Title: **Proposed Strategic Housing Development At Ballymany
Combined Stage 1&2 Road Safety Audit**

Client: **Briargate Developments Newbridge Limited/Muir
Associates**

Date: **May 2021**

Report reference: **1035R01**

Drawing D1920-MAL-00-XX-C-002 Rev B, 003 Rev A, 004 Rev A & 005 Rev A, Overall main access road.

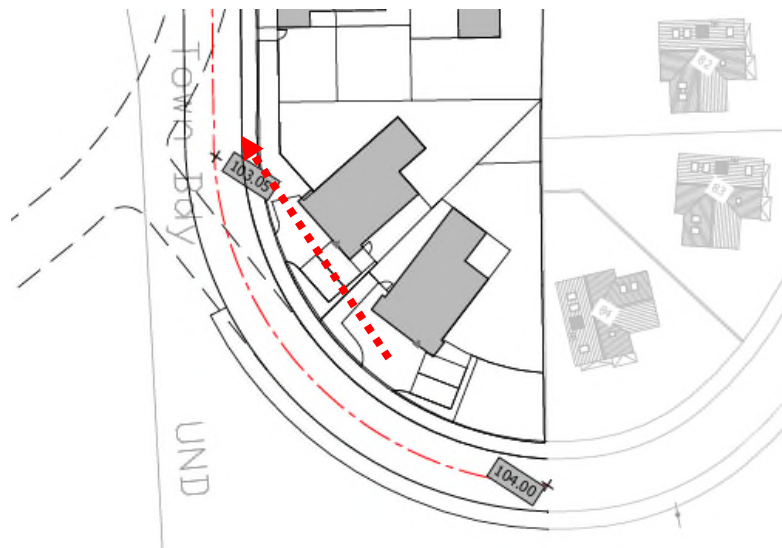
The main access road is relatively long. This could lead to high speeds and result in high injury severity if a vulnerable road user (e.g. a cyclists accessing the segregated cycle track) is struck by an errant vehicle.

It is recommended that traffic calming features be provided on the main link road of the development that will lead to speeds of 50km/hr or lower.

3.1	NO	NO	The Link Road is part of a previously permitted development on the site and forms part of the Newbridge LAP Roads Objective 05(b). The design of the horizontal and vertical alignments of the Link Road together with the frequency of junction spacing at designated intervals provides for a traffic calming effect. It is also worth noting that the part of the southern section of the Link Road is limited to 30 km/h and incorporates a raised pedestrian crossing in order to reinforce the traffic calming effect.	Yes

Drawing D1920-MAL-00-XX-C-002 Rev B, Visibility from driveway, most southern unit.

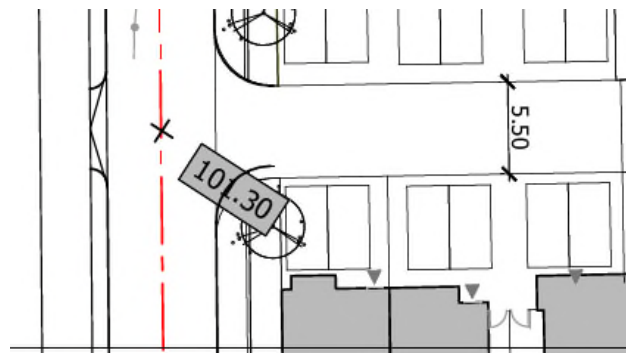
The most southerly unit is located on a sharp bend of the main access road. There is a risk that drivers exiting this premises may not have adequate visibility to approaching southbound vehicles. This could result in collisions.

It is recommended that suitable visibility be provided.

3.2	YES	YES	Note: An appropriate visibility splay for the Plots in question will be demonstrated as a part of the planning application drawings.	Yes
3.3	YES	YES

Drawing D1920-MAL-00-XX-C-002 Rev B, 003 Rev A, 004 Rev A & 005 Rev A, Trees within visibility splays.

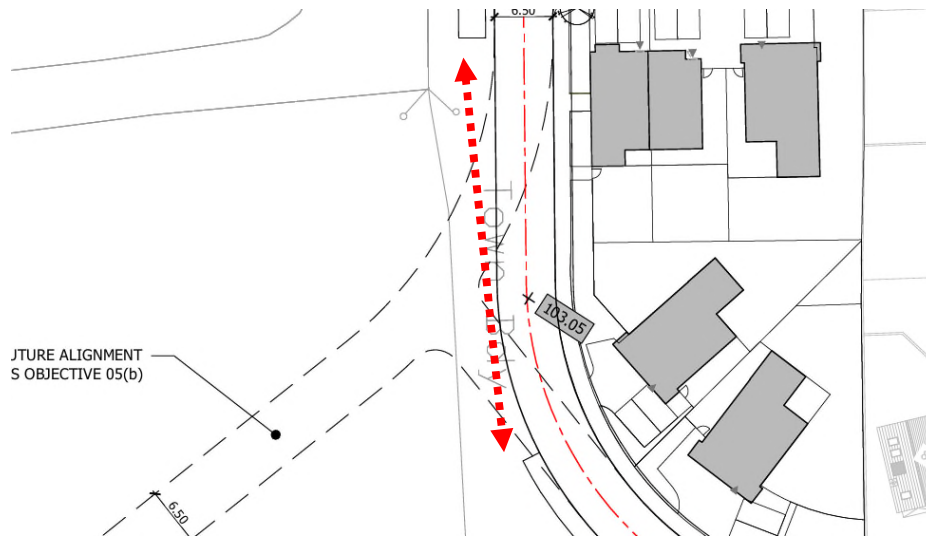
Throughout the proposed development trees are shown at the internal junctions. There is a risk that these trees could obscure inter-visibility between drivers and pedestrians. This could lead to collisions.

Ensure trees do not block visibility splays.

Drawing D1920-MAL-00-XX-C-005 Rev B, Standhouse Road Junction.

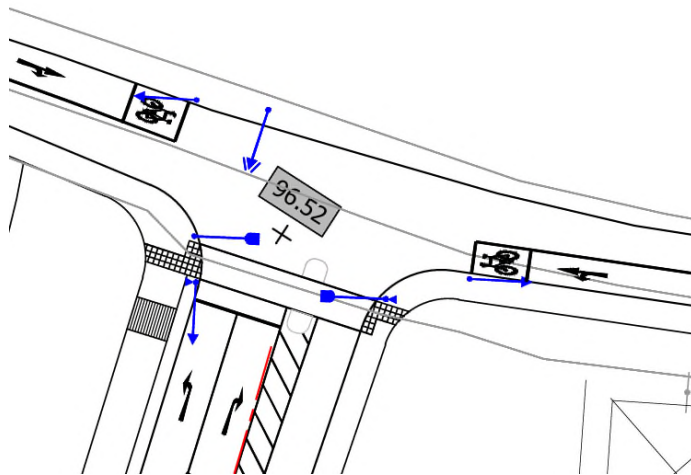
It is proposed to provide advanced stacking facilities for cyclists at both sides of the proposed Standhouse Road junction. There are no feeder lanes to those stacking facilities and as a result cyclists may try and weave through traffic to get there. This could lead to side-swipe collisions with general traffic and cyclist frustration if they cannot access the facility.

It is recommended that a box turn facility or similar be provided.

3.5	YES	NO	Given the existing constraints associated with Standhouse Road it is not feasible to provide cyclist box turning at this time. Advanced stacking facilities will be excluded from the junction design in order to eliminate the highlighted potential	Yes

conflicts between cyclists and other road users.	
3.6	YES	YES	Note: The facility on the western side of the Link Road is a two-way cycle track and a toucan crossing will be provided as a part of the Stanhouse Road junction design in line with the audit recommendations.	Yes
3.7	YES	YES		
3.8	YES	YES		
3.9	YES	YES

Drawing D1920-MAL-00-XX-C-005 Rev B, Standhouse Road Junction.

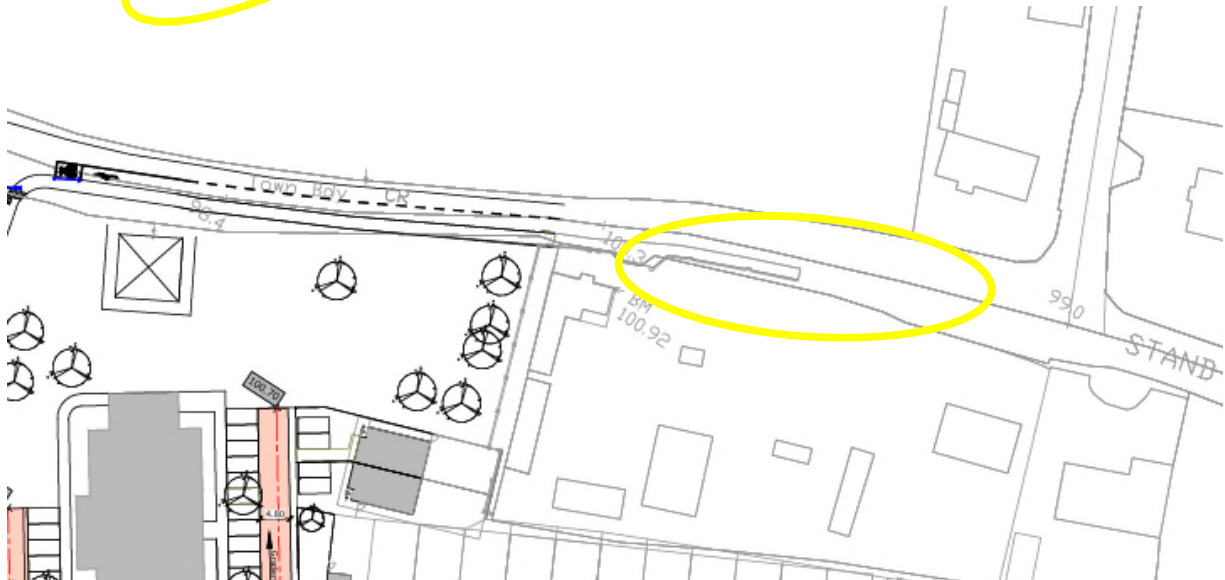
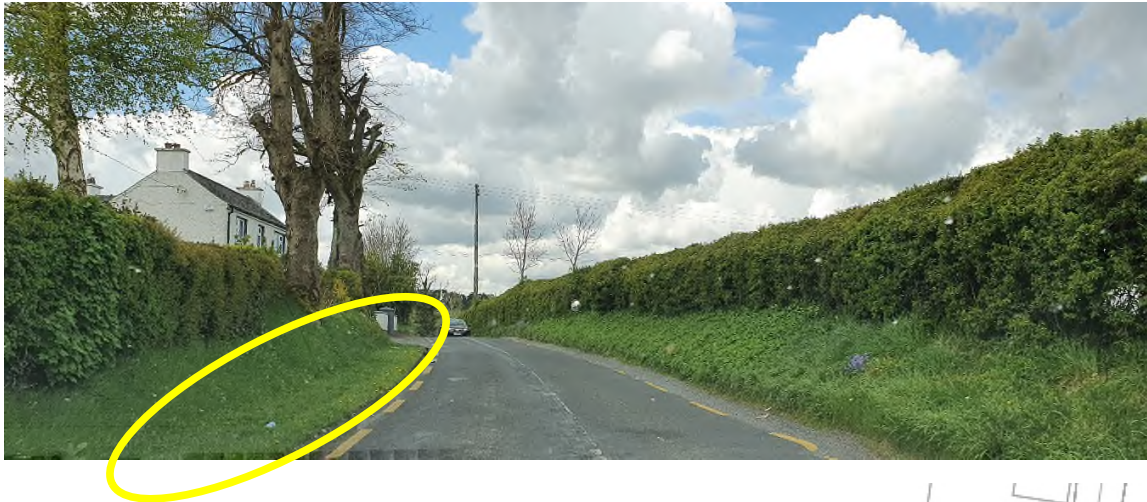
It is unclear if the proposed vulnerable user facility on the western side of the main access road is a shared use pedestrian cycle facility and if it is to be for one or two-way cycling. Without adequate width and adequate access facilities there may be collisions between cyclists and pedestrians.

It is recommended that if the facility is to be for two-way cycling that the proposed signalised pedestrian crossing be upgraded to a toucan crossing, if not, then a southbound cycle facility should also be provided.

Drawing D1920-MAL-00-XX-C-005 Rev B, Standhouse Road Carriageway Width.

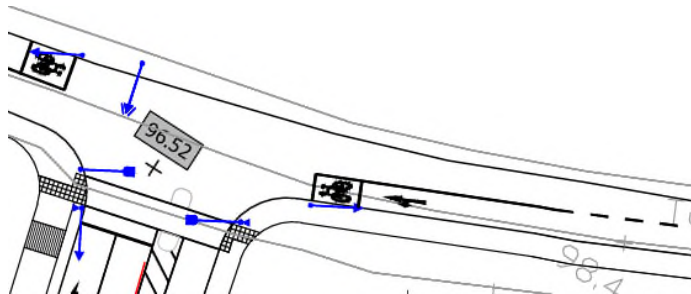
The existing carriageway width at Strandhouse Road is narrow and passing vehicles use the narrow verge to gain extra space when passing. With the introduction of the footpath in the southern verge the effective width of the carriageway will be reduced and this could result in side-swipe collisions.

It is recommended that the Strandhouse road carriageway width be sufficient to allow queuing and passing of vehicles.
